Title: SkyRise Roof Replacement

Applies To: ProStar Skyrise

DESCRIPTION

Figure 2: New Notch**Figure 3:** New notch overlayed over old notch (red area should be removed).

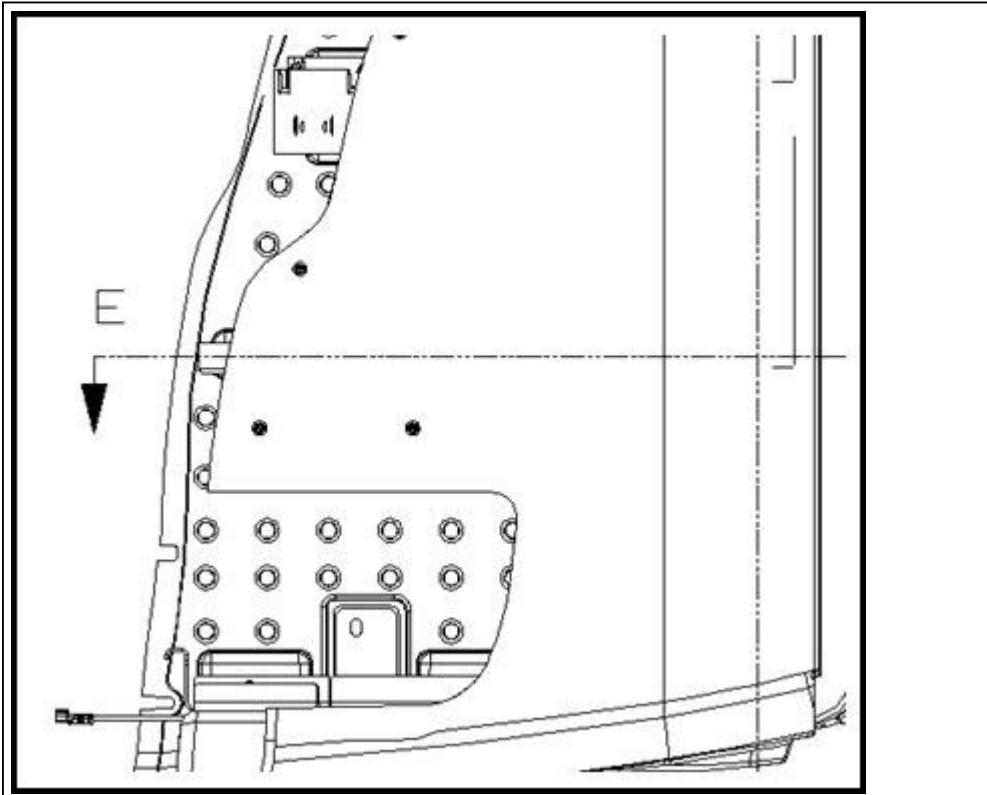
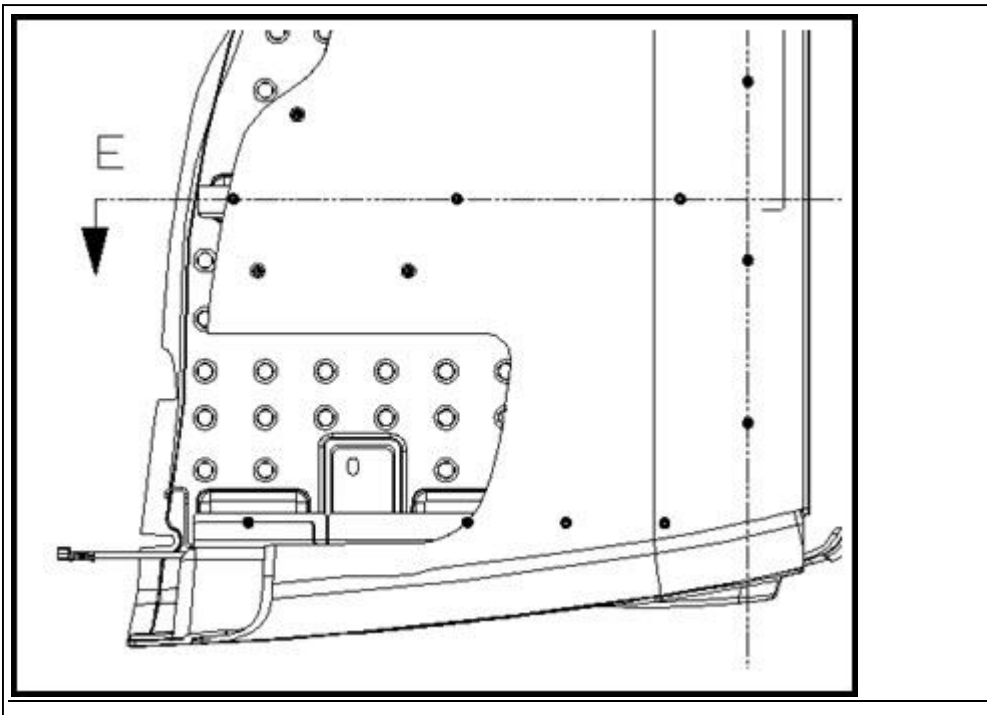
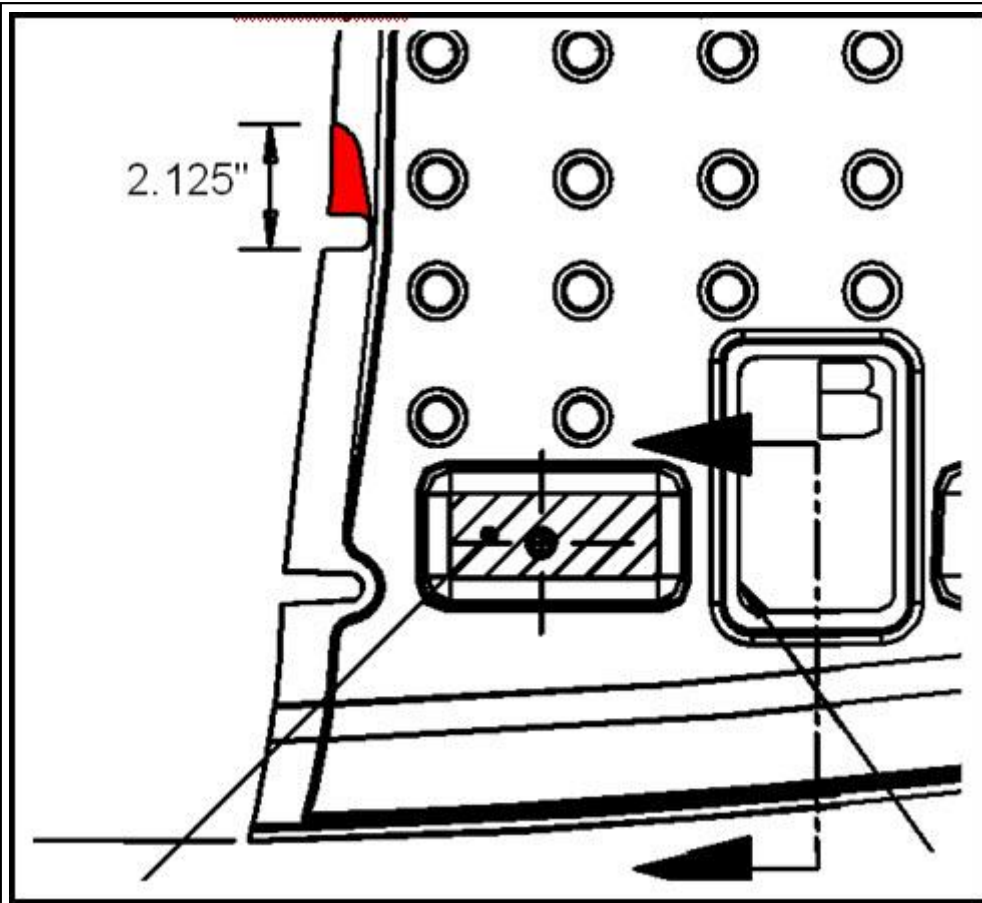
1. Cabinets should be modified to provide clearance to the roof reinforcement.

Figure 5: New Bracket Orientation

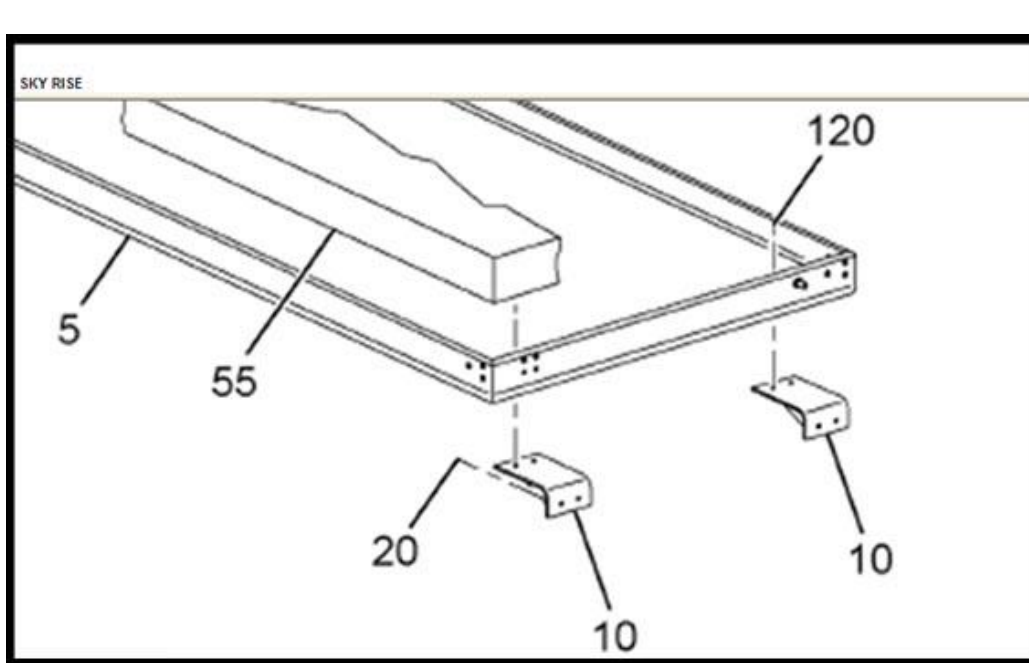
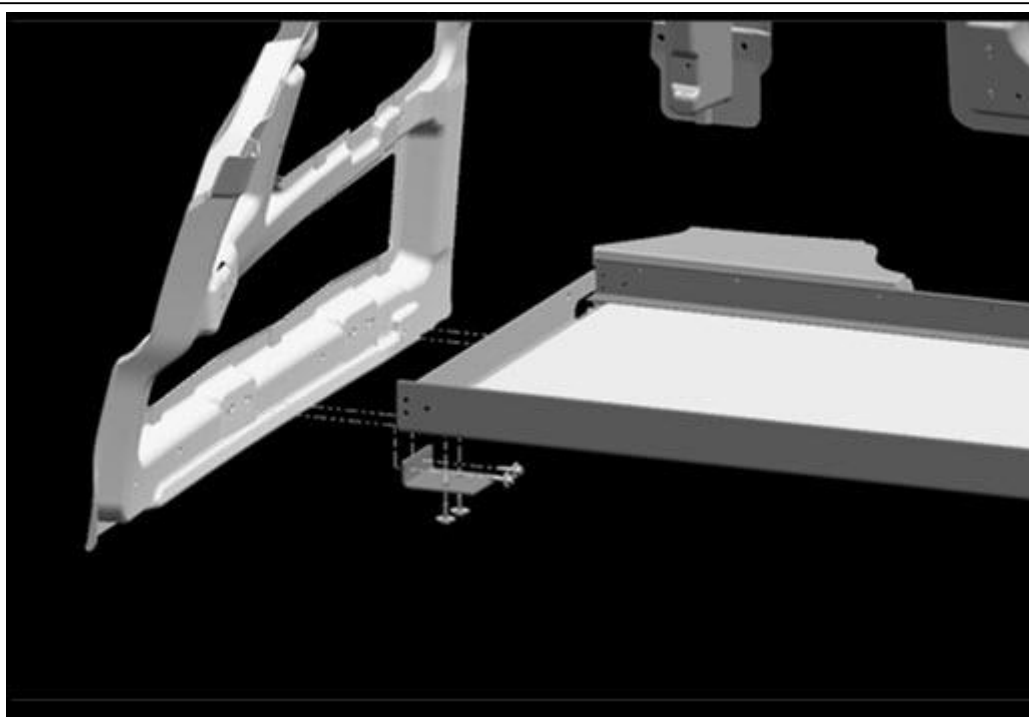
2. Upper bunk mounting brackets should be inverted during installation, meaning all 4 brackets should be rotated 180 degrees when installed into the new roof.
